**ADDENDUM NUMBER: THREE**

**ISSUED BY: SEPW Architecture Inc.**  
 109 – 3725 Pasqua St., Regina, SK. S4S 6W8  
 PH. (306) 569-2255

**PROJECT: INTERIOR FIT-UP  
 REGINA, SASKATCHEWAN**

# MOBILE SHELVING – CLEARANCES

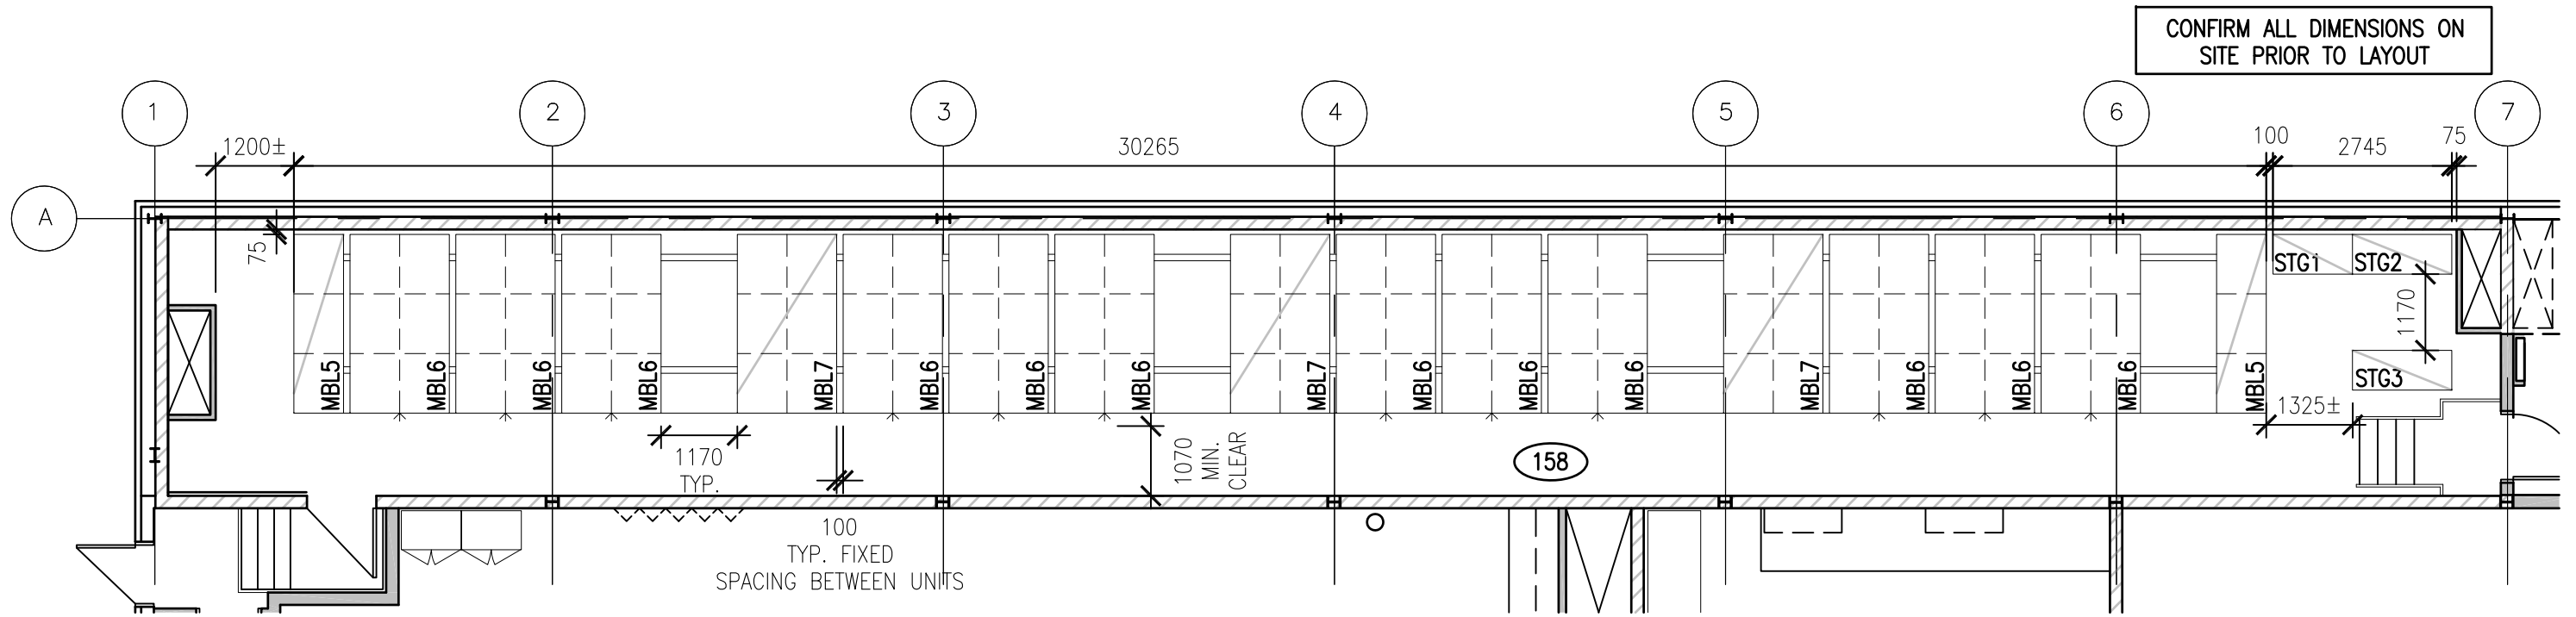
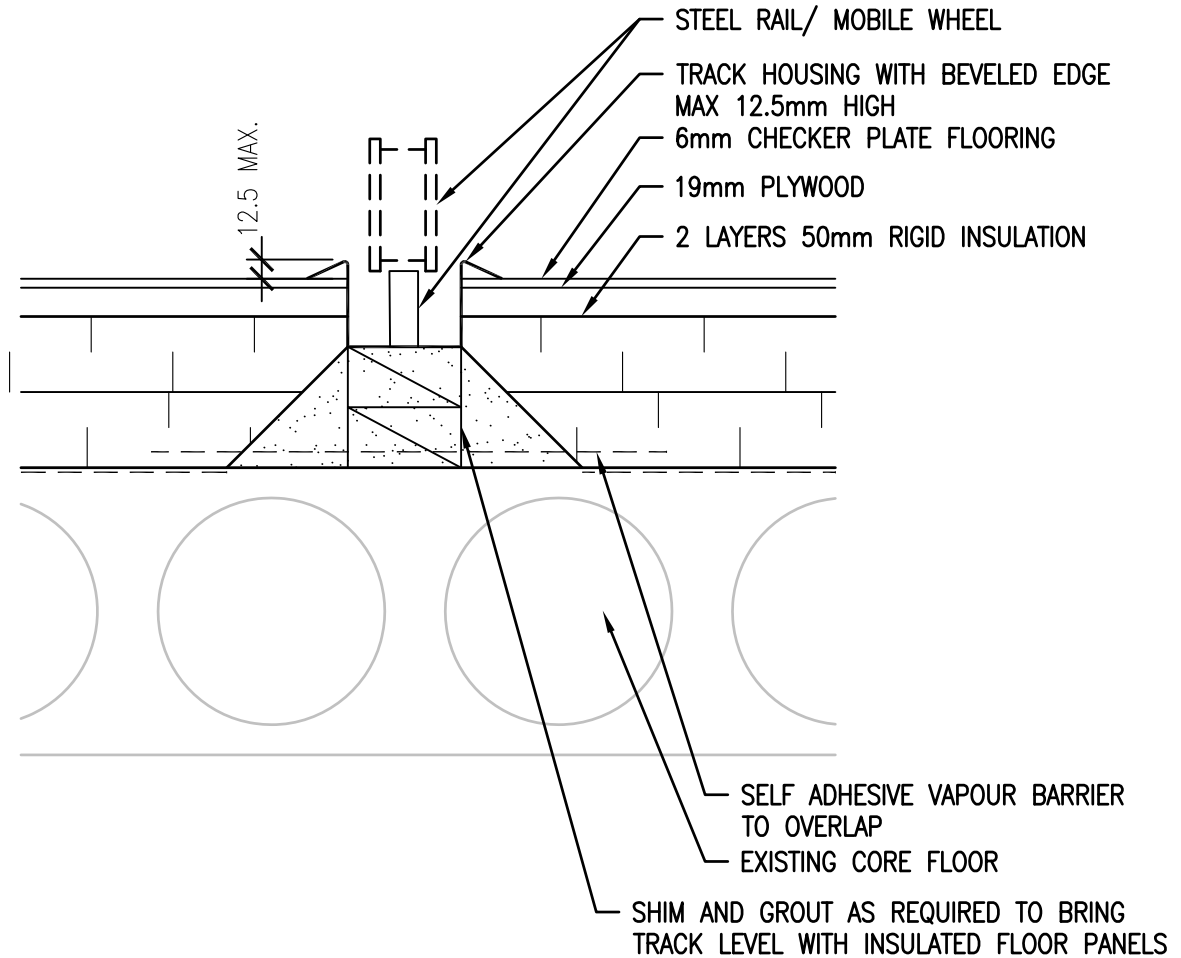
**A-3-9 REF. DRAWING AR-3 – MOBILE SHELVING CLEARANCES**

- .1 ADD: clearance dimensions as shown on AR-3 for mobile storage system. Confirm clearances prior to layout.
